IEC/IEEE 80005-1

AMENDMENT 1

**Utility connections in port –
Part 1: High voltage shore connection (HVSC) systems – General requirements**

Figure C.4 – Three-phase ship connector and ship inlet contact assignment

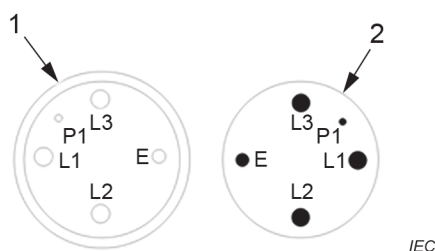
Replace the existing figure and key with the following new figure, key and note:

- 1 Ship connector face
- 2 Ship inlet face
- E Earth
- P1 Pilot line 1 (used for continuity check)
- L1 Phase A – phase R
- L2 Phase B – phase S
- L3 Phase C – phase T

NOTE Pins are showed as solid circles and sockets as open circles.
